## UTTAR PRADESH METRO RAIL CORPORATION LTD.

### ADDENDUM-4

**Name of work: AGCC-07:** Design and Construction of Main Line Elevated Viaduct from Agra Cantt. Metro Station to Kalindi Vihar Metro Station [Chainage (-77m to 15016m) including Viaduct Connection with Ramp (Chainage 0.00m to 2610m) from (nearby) Sadar Bazar Metro Station to existing Corridor-1 Depot at PAC ground & Corridor-2 Depot Entry/Exit lines Viaduct with Ramp (Chainage 0.00m to 530m) and 14 nos. of Elevated Stations i.e., Agra Cantt, Sadar Bazar, Pratap Pura, Collectorate, Agra College, Hariparvat Chauraha, Sanjay Place, M.G. Road, Sultanganj crossing, Kamla Nagar, Ram Bagh, Foundary Nagar, Agra Mandi & Kalindi Vihar metro stations including Civil, Associated Ancillary Structures, Architectural Finishes, Water Supply, Sanitary Installation, Drainage, External Development, Fire Fighting, Fire Detection, E&M works and PEB structures in Corridor-2 of Agra Metro at Agra, Uttar Pradesh, India.

**PROJECT:** KANPUR & AGRA METRO RAIL PROJECT : CORRIDOR-2  
**CLIENT:** UP METRO RAIL CORPORATION LTD.  
**TITLE:** SPAN ARRANGEMENT - AGRA CORRIDOR  
**SHEET 13**

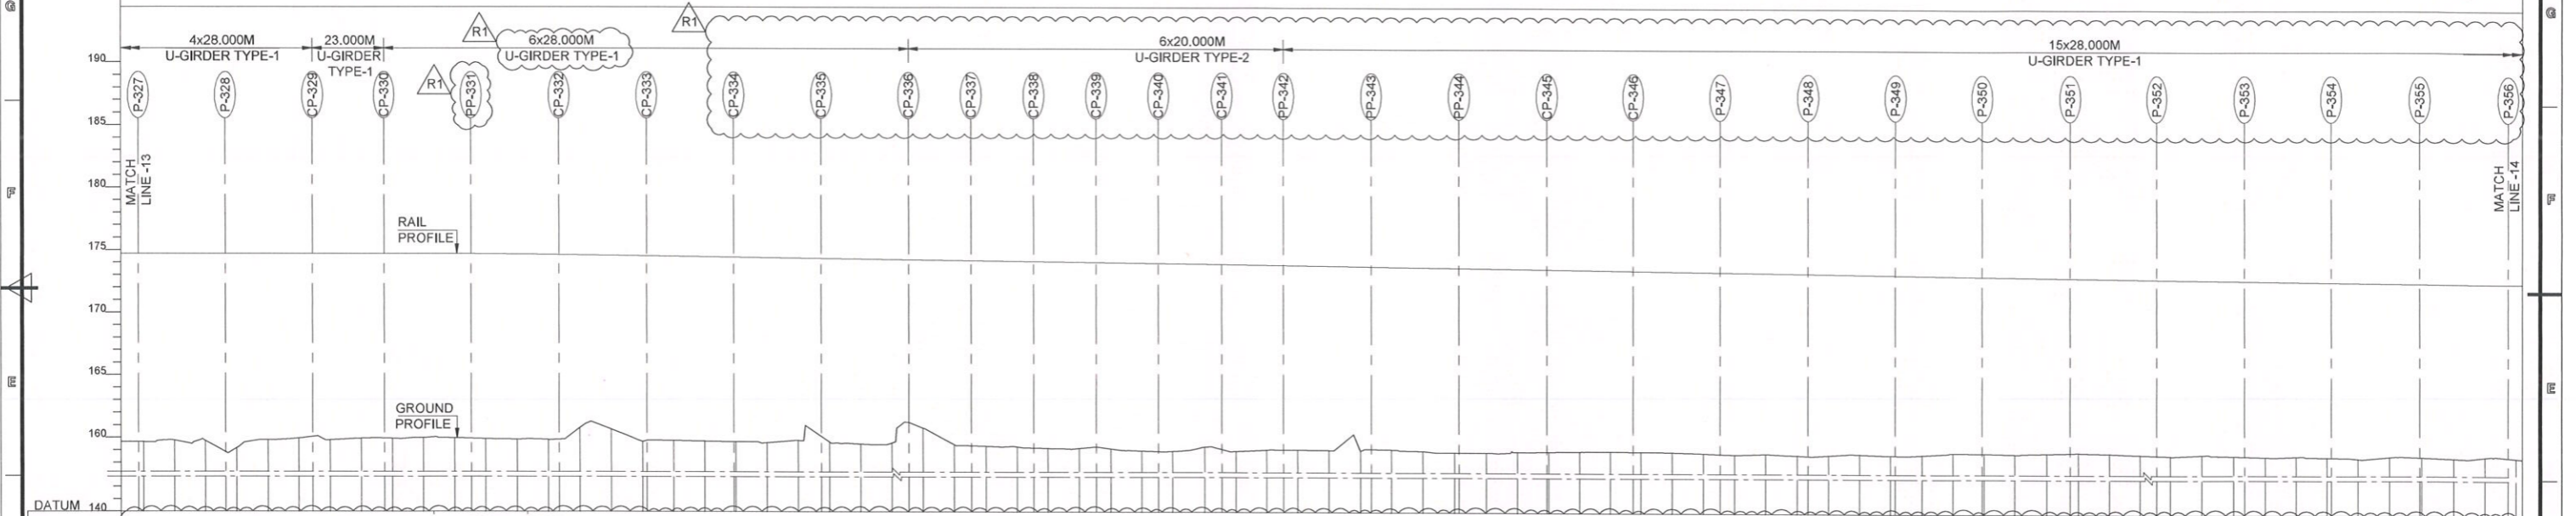
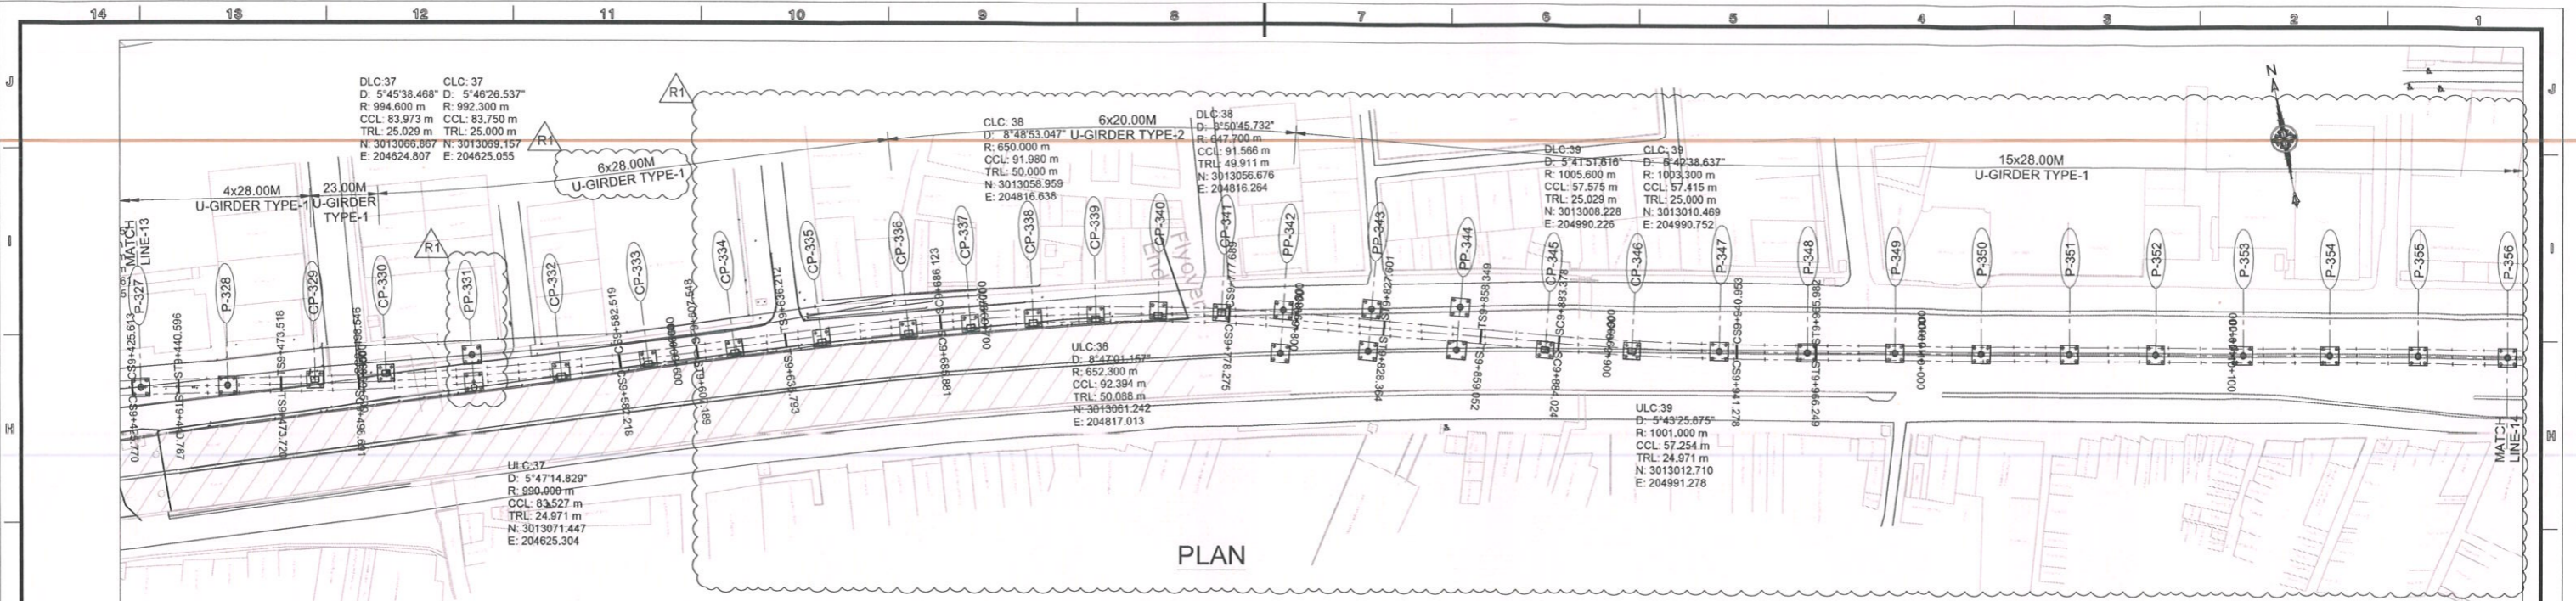
Sl. No.	Reference Volume / Clause	Existing Clause	Queries	UPMRC's Reply
72	Vol-6, Tender Drawings	Title:- Span Arrangement-Agra Corridor Sheet 13. Drawing No.-: KNPAGDDC-01-TDR-ELV-VDC-DWG-09033.	Sultanganj station is passing over nallah, we presume that cost of diversion/reconstruction of nallah is payable separately, <b>kindly confirm.</b>	As per Tender Condition
73	Volume 3, Employers Requirements- Functional, Cl. 2.1.A.3, Pg. 25-26	The shifting of the utility(ies) would be undertaken only in exceptional circumstances where in the opinion of the Engineer no other option is available. Shifting/diversion cost of all the charted utilities is included in Lump Sum price of Schedule-A.	We request you to <b>provide the drawings</b> indicating Location and details of the charted utilities in the subject clause.	As per Tender Condition
74	Vol-3, Employer's Requirements/SectionB/ Functional Part-1, Clause 2.1.A (i), Page No. 20	Construction of super structure of standard U-Girder span (28m) and all other spans upto 28 m for straight and for curves more than 300m radius, standard Pier cap, Bearing (Elastomeric) & crash barrier as per tender drawing. The design of standard span U Girder and all other spans upto 28 m for straight and for curves more than 300m radius, standard Pier Cap, bearing (Elastomeric), bearing pedestal & crash barrier for these spans shall be provided by UPMRC. Also, the reinforcement in the U-Girder, standard Pier Cap & bearing pedestal shown in tender drawing is the minimum reinforcement to be provided. However, in case the contractor assesses that the reinforcement has to be increased then the same shall be provided after approval of UPMRC without any extra cost.	As per our understanding Design of standard span U Girder and all other spans upto 28 m for straight and for curves more than 300m radius, standard Pier Cap, bearing (Elastomeric), bearing pedestal & crash barrier are not in contractor's scope, based on this understanding kindly clarify the clause of reinforcement. Kindly clarify U girder with sharper radius upto span GAD and drawings have 23m span curve R=215m.	As per Tender Condition. Kindly refer <b>Annexure - 7 of Addendum also.</b>

TITLE: **SPAN ARRANGEMENT - AGRA CORRIDOR**  
 SHEET 16

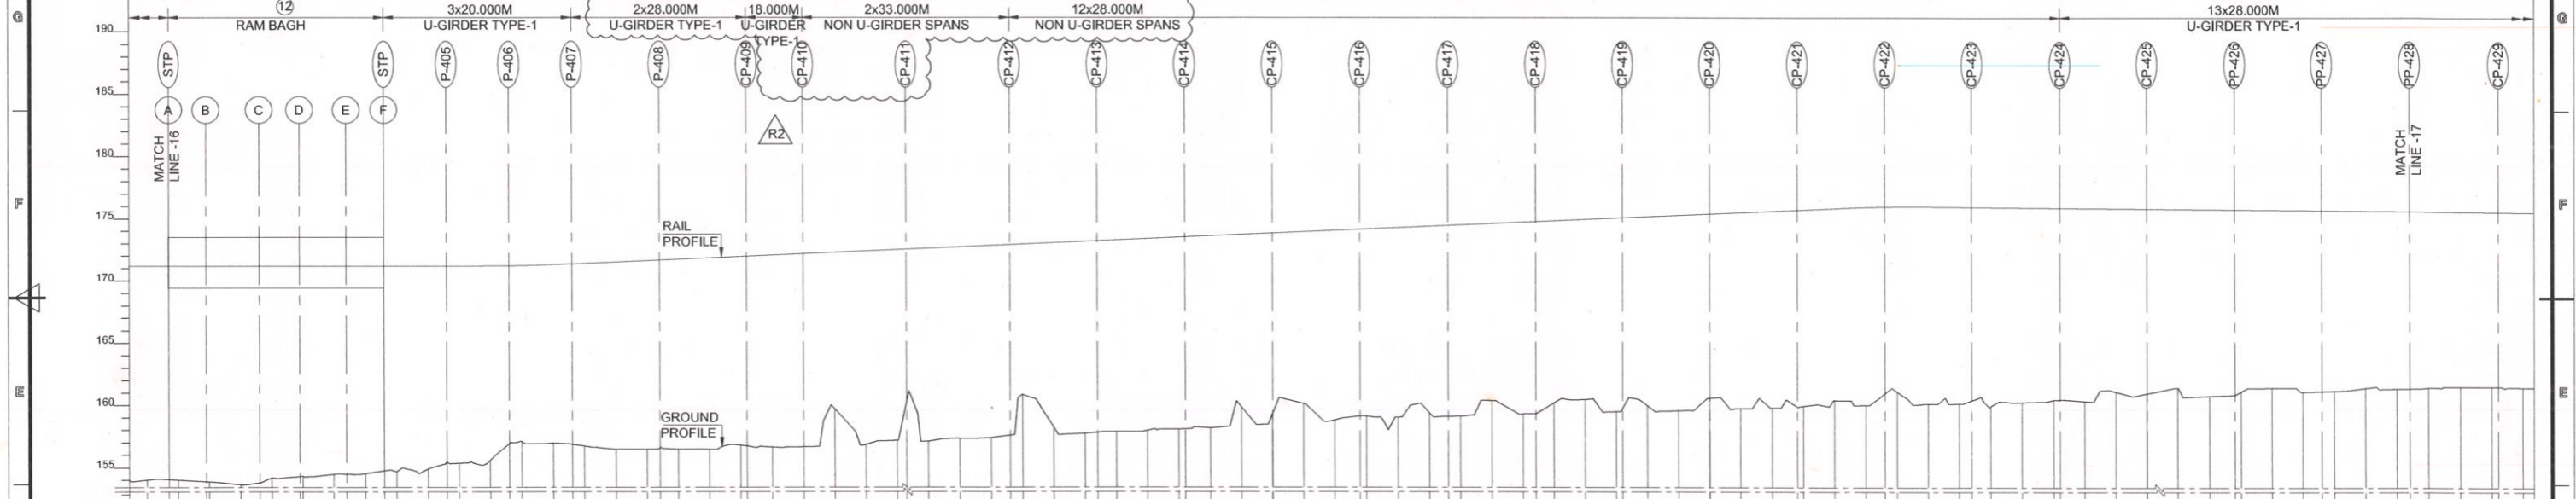
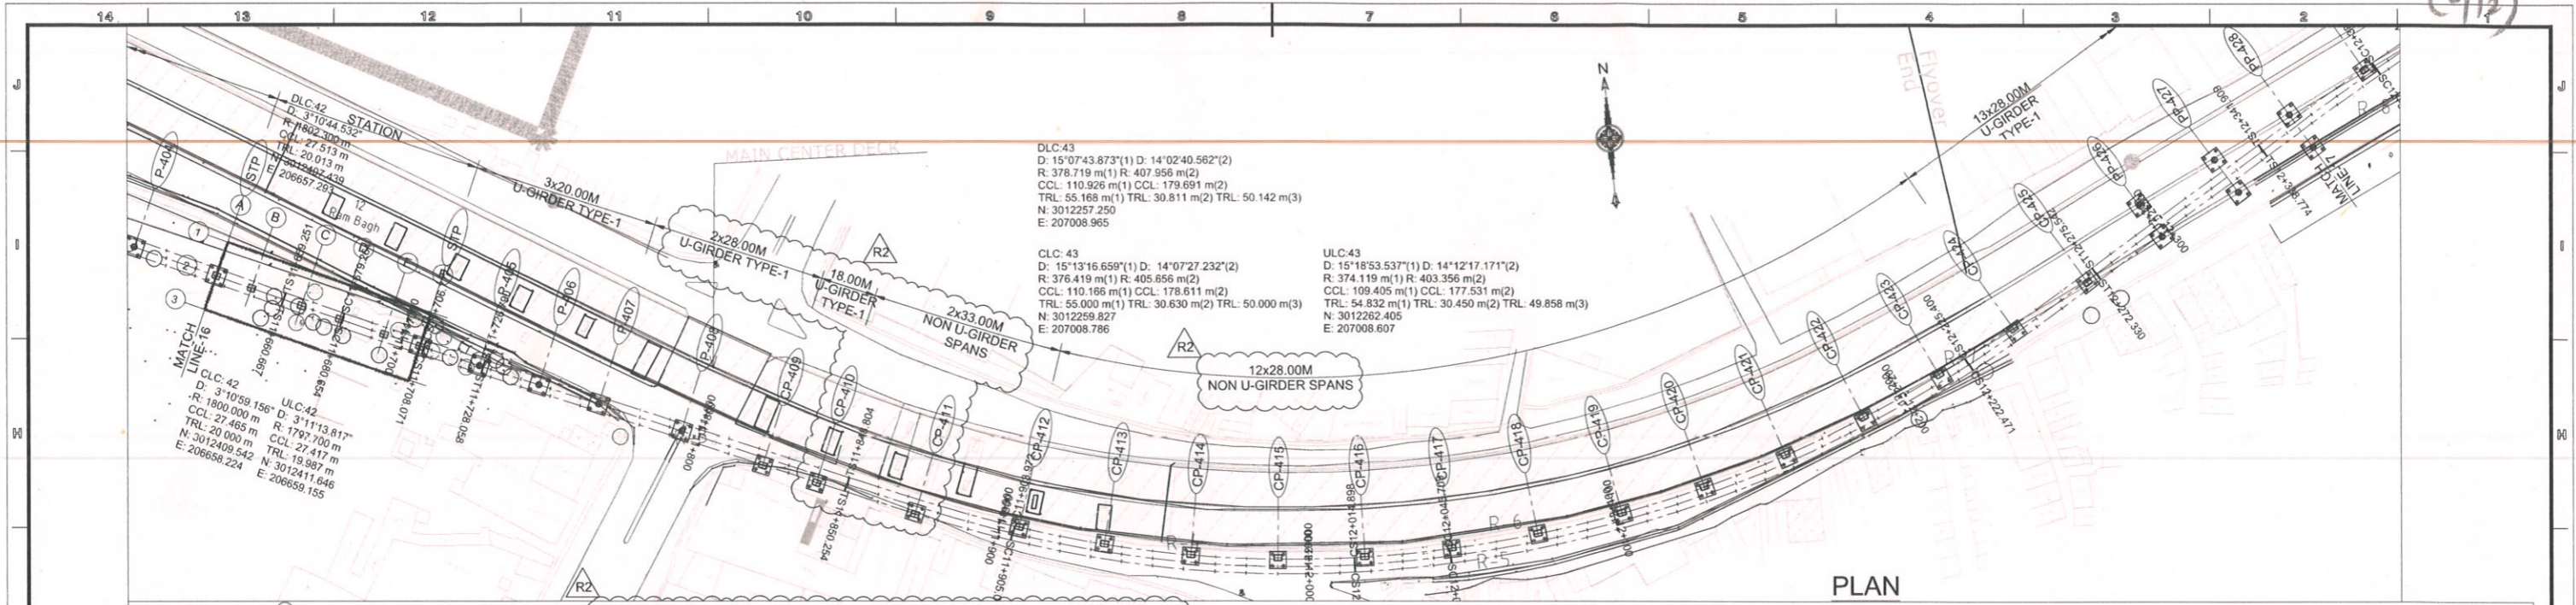
80	Vol-6, Tender Drawings & Vol-3, Employer's Requirements/SectionB/ Functional Part-1, Clause 2.1A (vii, e), Page No. 21	Title:- Span Arrangement-Agra Corridor Sheet 16. Drawing No.-: KNPAGDDC-01-TDR-ELV-VDC-DWG-09036. Steel I Girder Span-6X45.720M (Approx) + 47.32M    Special Span – 34 Mtr. + 7 x 45 mtr. + 34 Mtr. – (383 Mtr. Yamuna River Bridge)	Total length of Steel I girder span over Yamuna river is different in tender drawing (322M-6X45.72M+47.32M) & Employers requirement (383M-34M+7x45M+34M). <b>Please clarify</b> the correct length of spcial span to be constructed over Yamuna river.	Kindly refer <b>Annexure-2 &amp; 3 of Addendum</b> .
81	Vol-3, Employer's Requirements/SectionB/ Functional Part-1, Clause 2.1.C (e), Page No. 33	Provision of suitably designed pile foundations for piers in accordance with actual soil parameters as obtained from detailed sub surface exploration as required or as directed. All foundation shall be on piles of minimum 1000 mm dia. with <u>minimum 8mm thick permanent MS liners</u> as per requirements, for complete pile length above hard/ rocky strata duly anchored as per Codal provisions. All piles shall be cast-in-situ piles bored by hydraulic rotary rig only;	Bidder understands that permanent liner is not mandatory to be provided only at location wherever required.Please confirm.	Kindly refer clause 17 of ER/ Construction/ Vol-3 of tender document. Provision of permanent liner shall be as per site/ geotechnical requirements.
